Dublin Cycling Campaign,

22 June 2020

Planning reference: Randelswood Holdings Ltd., Strategic housing development at lands at Palmerstown Retail Park, Kennelsfort Road Lower, Palmerstown, Dublin 20
<https://www.palmerstownshd2.ie/>

Image taken from page 26 from Traffic & Transport assessment section
*Figure 3.2 – Proposed Site Access onto Kennelsfort Road (AECOM Drawing:
 PR224738-ACM-00-00-DR-CE00-0001)*

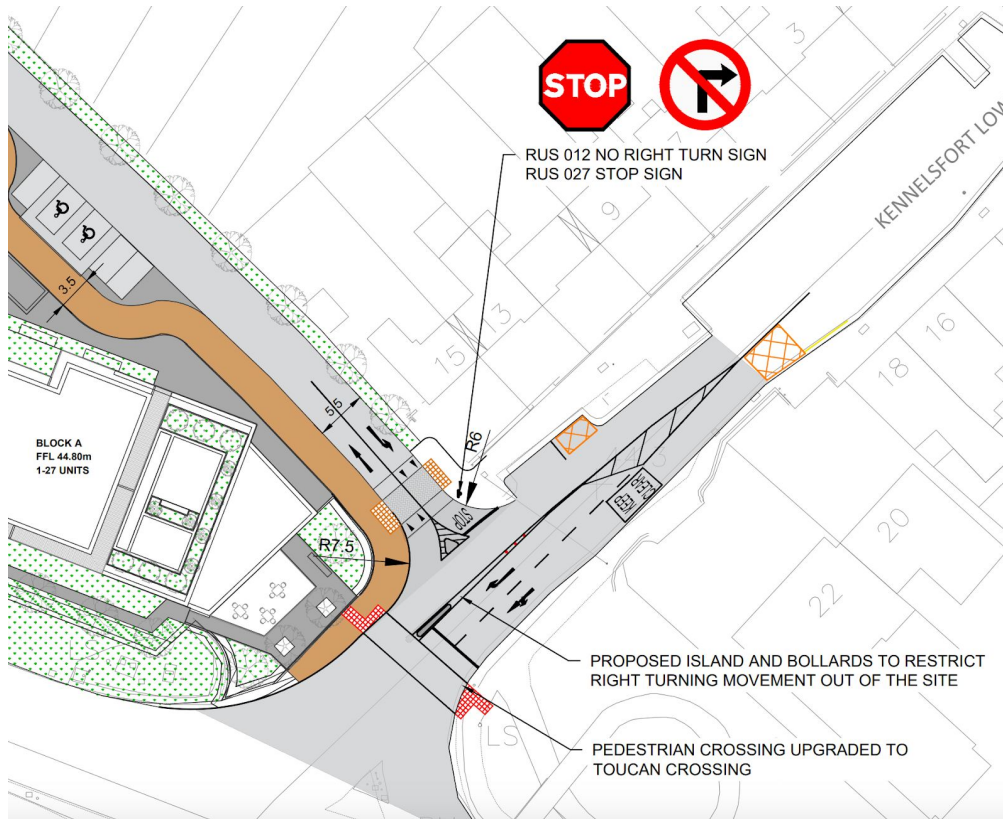
The engineering drawings in Figure 4.42 'Proposed Road Layout' show that the corner radii on the two proposed entrances are 6.5m. Section 4.3.3 of DMURS states: In general, on junctions between Arterial and/or Link streets a maximum corner radii of 6m should be applied. The proposed 7.5m corner radii are overly large for the entrance to an underground car park.

If the planning authority deems to grant permission we request that a condition be attached to reduce the size of the two underground car park entrances in order to reduce the traffic hazard for people walking and cycling.

In the traffic and assessment report the document mentions that they are in adherence to Design manual for urban roads and streets - DMURS, there is a discrepancy on the radii mentioned in the plans and those that are referenced in DMURS in order to protect cyclists and pedestrians. Can this be clarified. We recommend smaller radii in order to slow traffic especially that traffic will be turning off a major road. It is also unclear from the designs where the "proposed cycling and pedestrian route is located and there are no clear images of this shown in the planning application.
